**Blythe Energy, LLC
700 Universe Blvd.
Juno Beach, FL 33408**

Blythe Energy Center Transmission Line Project
Request for Staff Approved Modification
(99-AFC-08T)
Response to Data Request

TECHNICAL AREA: Transmission System Engineering
AUTHOR: Ajoy Guha

BLYTHE ENERGY		JOB NUMBER	REV
BLYTHE PLANT GSU-GIS OH 230KV TRANSMISSION LINE		115210	B
CTG2 TAP STRUCTURE		DRAWING NUMBER S1-1

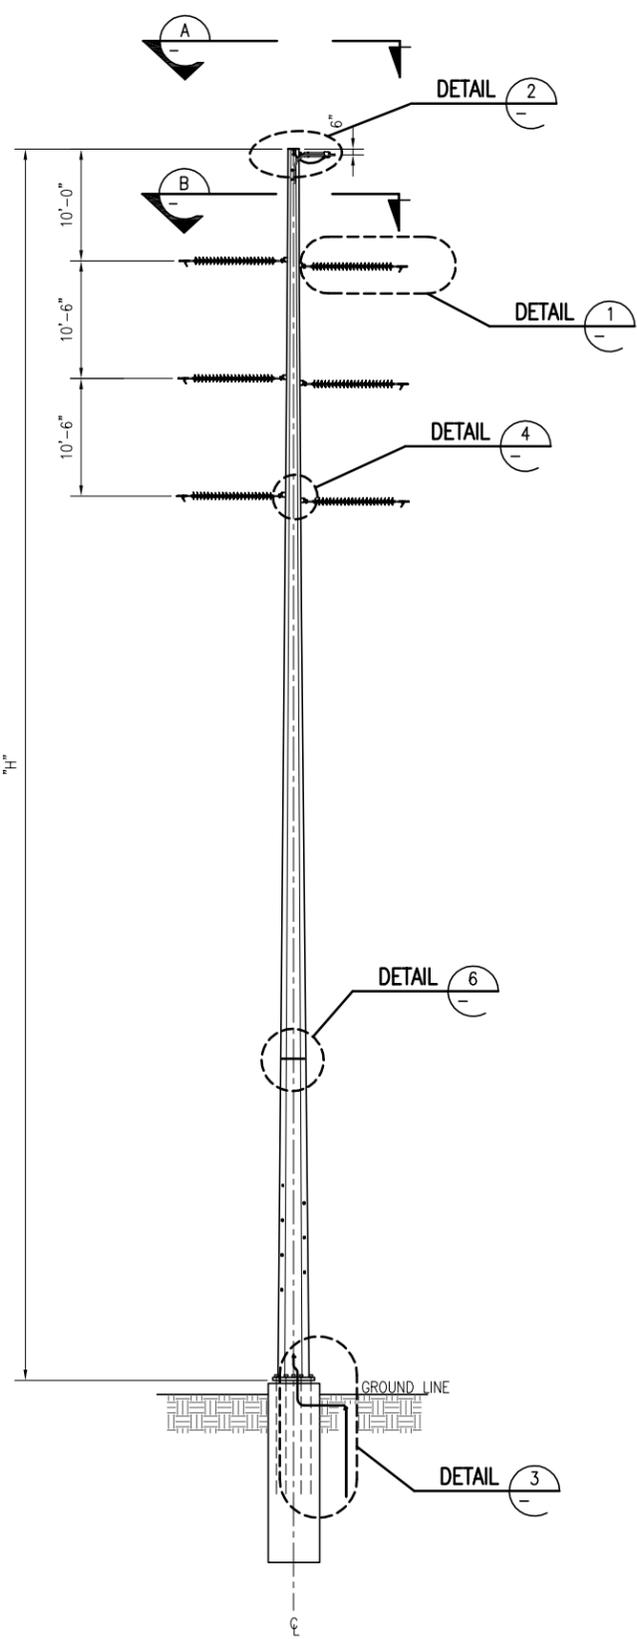
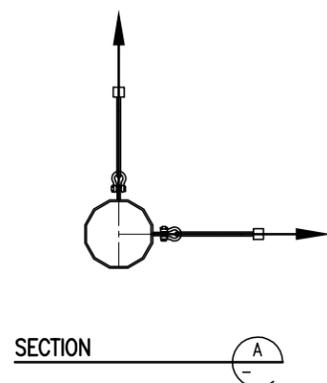
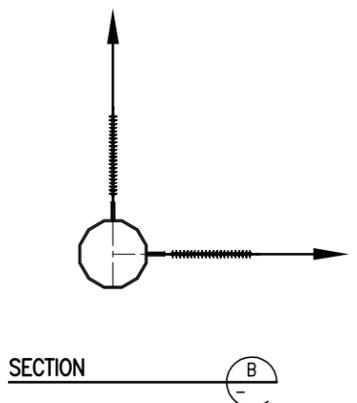
DATA REQUEST 2: Submit Pole design diagrams for intermediate and dead-end structures of the generator overhead 230 kV tie lines showing configuration of insulators and conductors with their respective position measurements on the pole. Provide the sizes, types and ampere rating of the overhead line conductors.

DATA RESPONSE 2: Please see Figure 4, sheet L1-1 and sheets S1-1 through S1-4A for requested design diagrams. The overhead conductor being used for the generator to GIS tap is: 1033.5 kcmil ACSR 'Curlew' with an ampacity rating of 1047 amps.

JOB NUMBER	REV
115210	B
DRAWING NUMBER	
P1-6

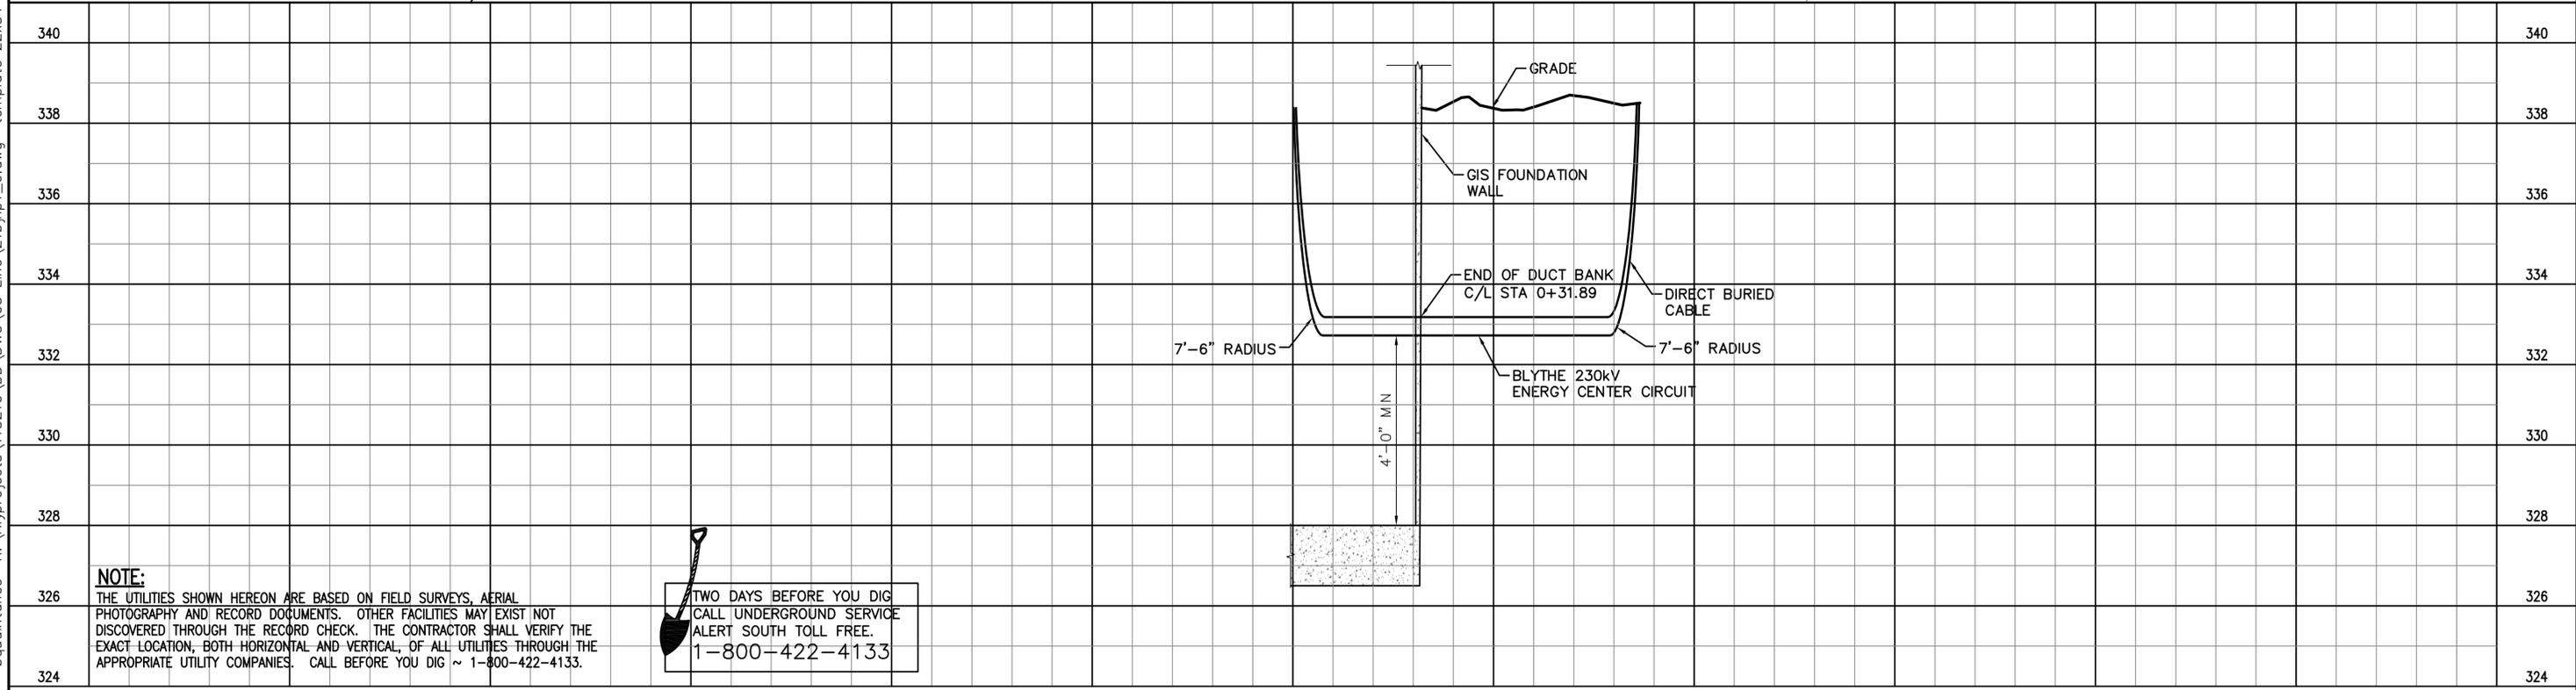
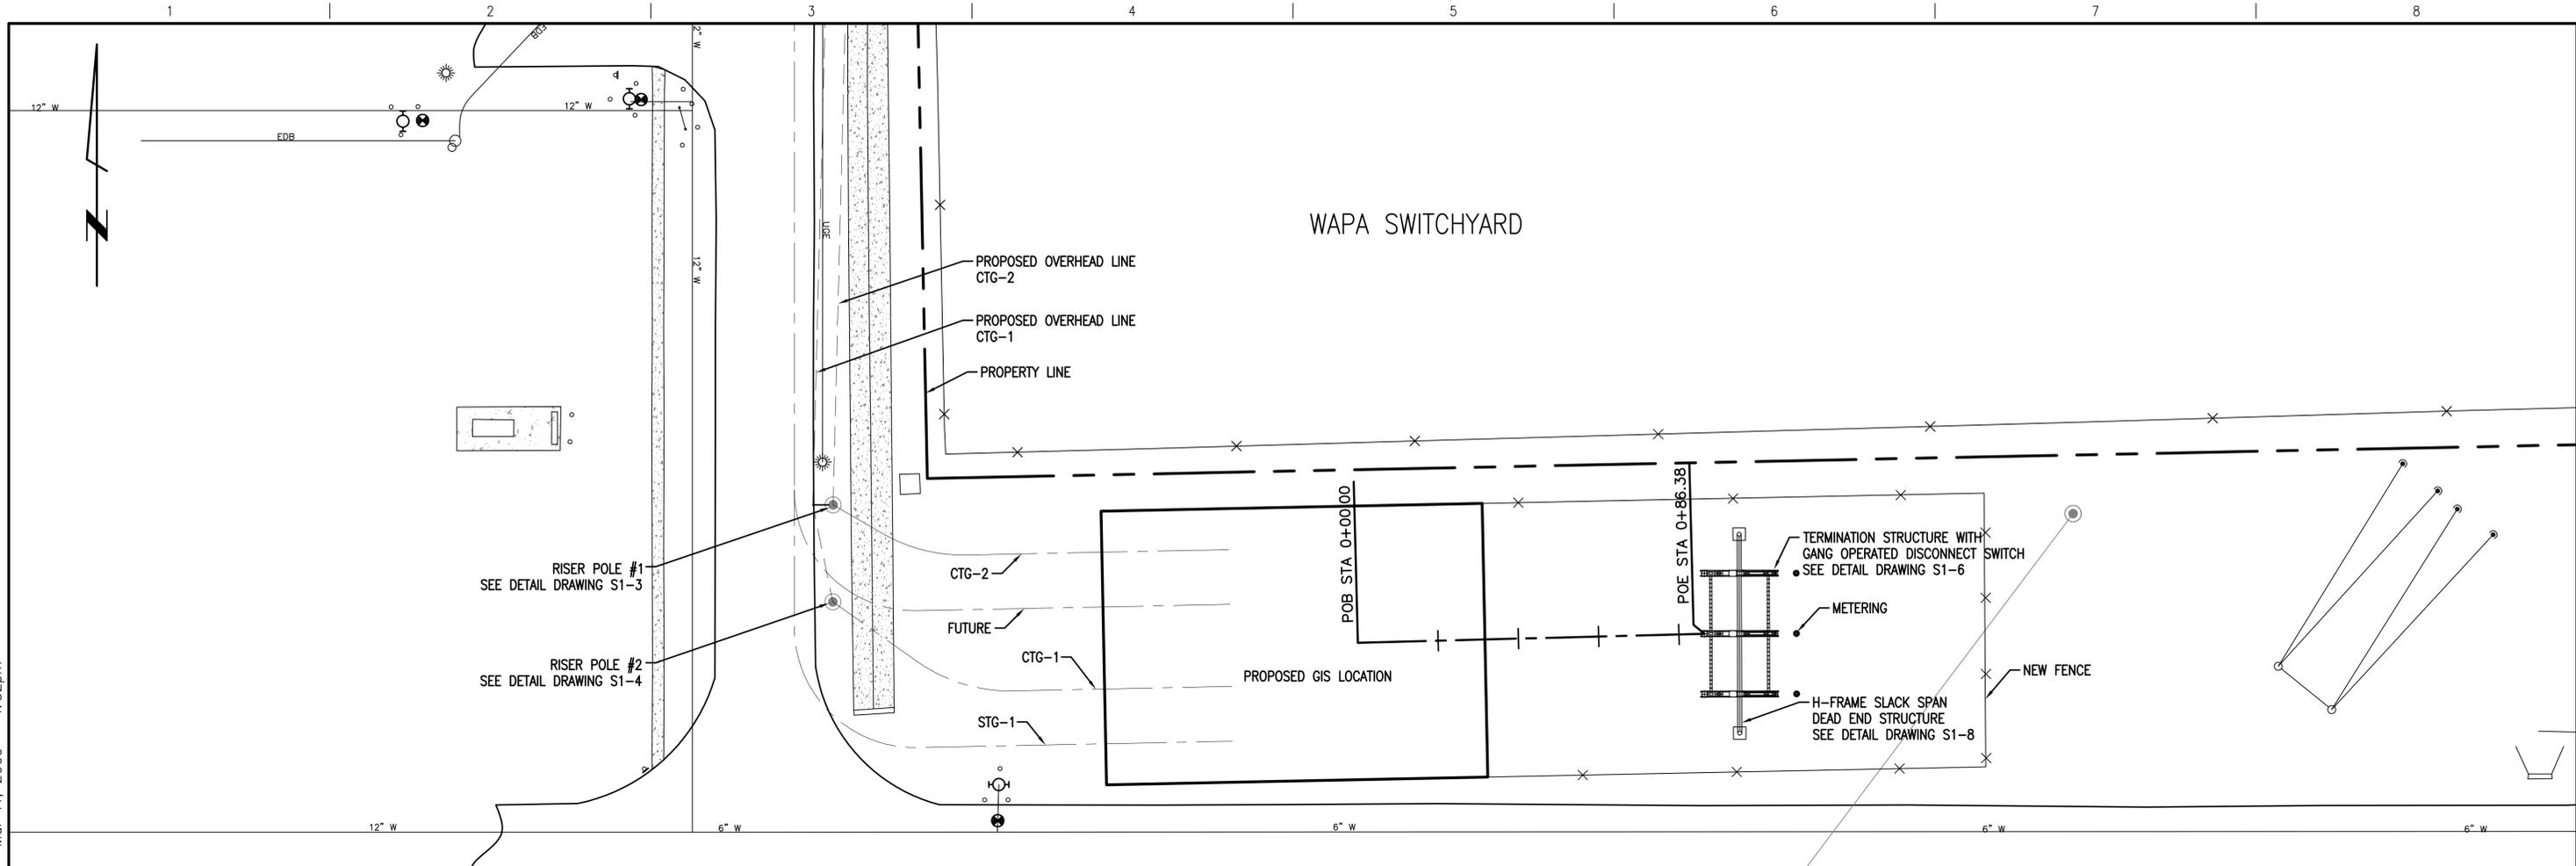
DATA REQUEST 6: Provide a scaled layout diagram showing how the existing BEP 230 kV transmission line to SCE Julian Hinds substation would be re-routed and connected to the new 230 kV GIS substation. Also provide a Pole design diagram with the overhead line conductor sizes and ampere rating.

DATA RESPONSE 6: Please see Figure 2, showing the scaled arrangement of the GIS, Figure 4, sheet P1-1, and Figure 5, Sheet P1-6. Overhead conductor being used for the generator to GIS tap is 1033.5 kcmil ACSR 'Curlew' with an ampacity rating of 1047 amps. The Blythe to Julian Hinds line conductor is triple bundled 1033.5kcmil ACSR 'Curlew' with an ampacity rating of 2008 amps.

JOB NUMBER	REV
115210	B
DRAWING NUMBER	
U0-1

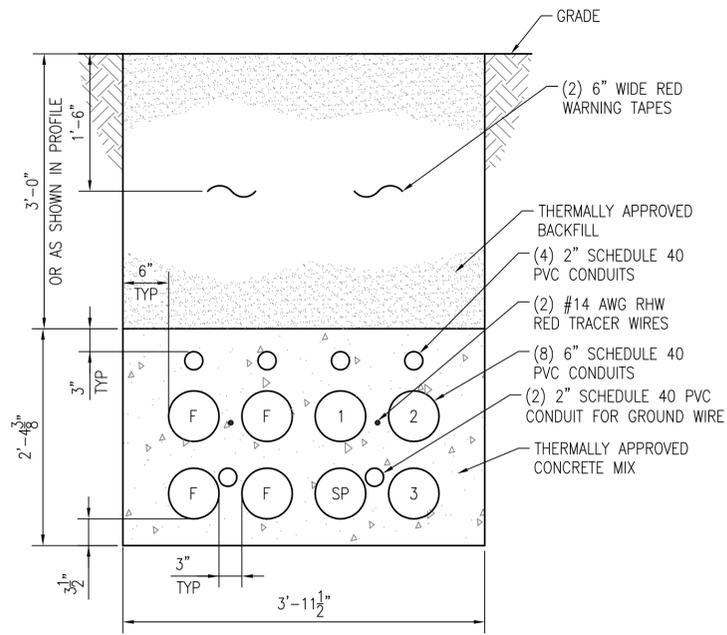
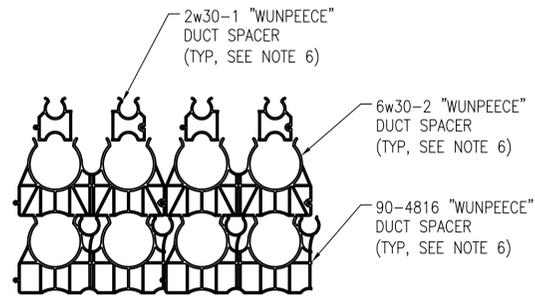
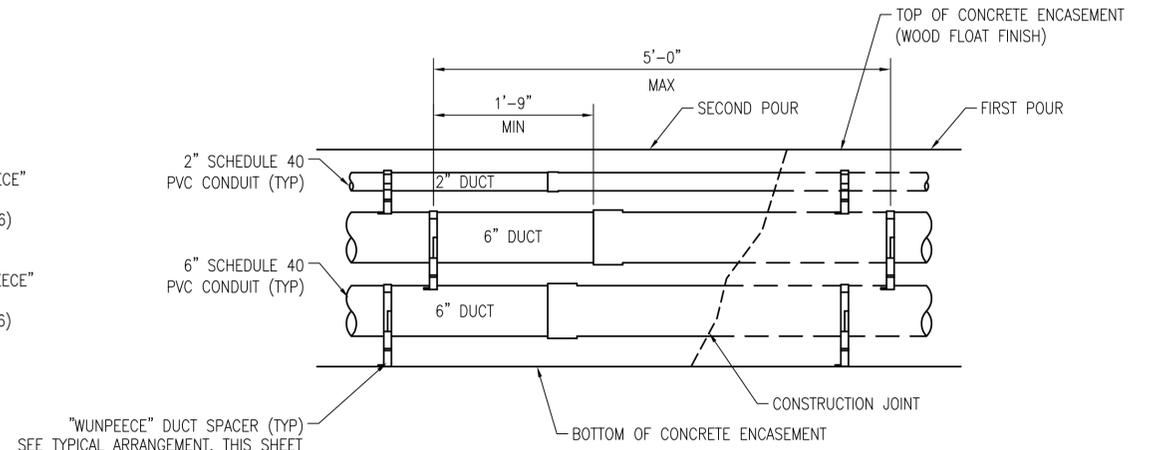
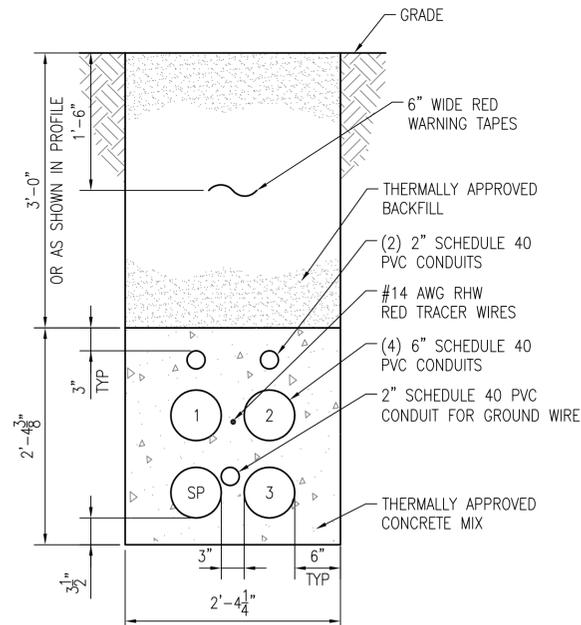
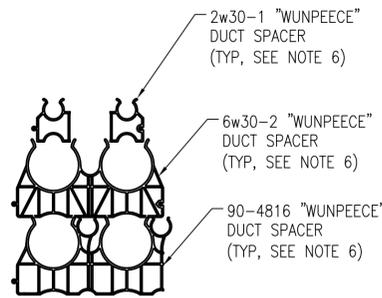
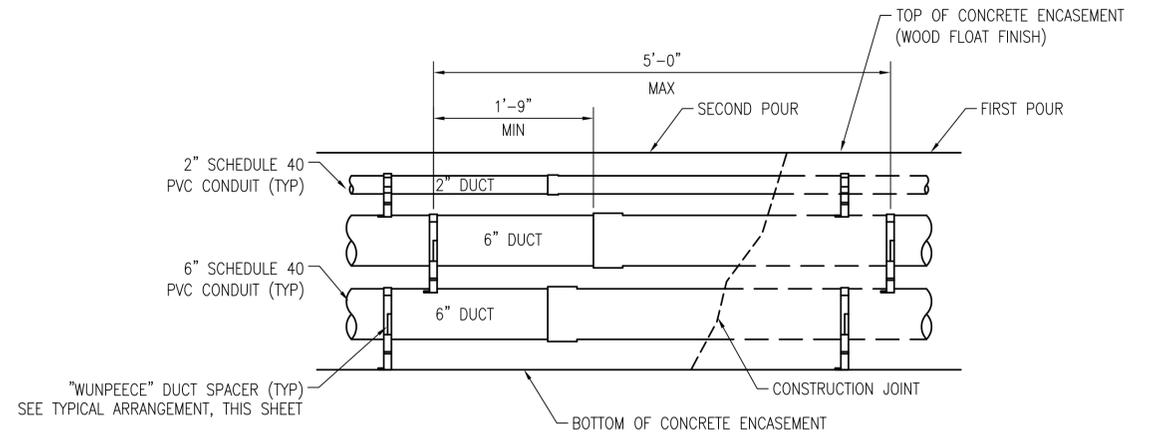
DATA REQUEST 4: Submit a design diagram of Duct Bank construction (or any other type) for the proposed 230 kV underground cable lines (including grounding and communication cables, if applicable). Provide the type, size and ampere rating of the 230 kV underground cables for all transmission outlets including BEP 230 kV line to Julian Hinds.

DATA RESPONSE 4: Please see Figure 5, sheets U0-1 through U0-3, for requested design diagrams of the duct bank construction for the proposed 230kV underground cable lines. The type, size, and ampere ratings are as follows:

For the interconnections from each turbine to the GIS, 1750kcmil copper conductor, carrying 457 amps, will be used. For the interconnection from the GIS to the Blythe-Julian Hinds 230kV transmission line, 5000kcmil copper conductor carrying 2058 amps will be used.
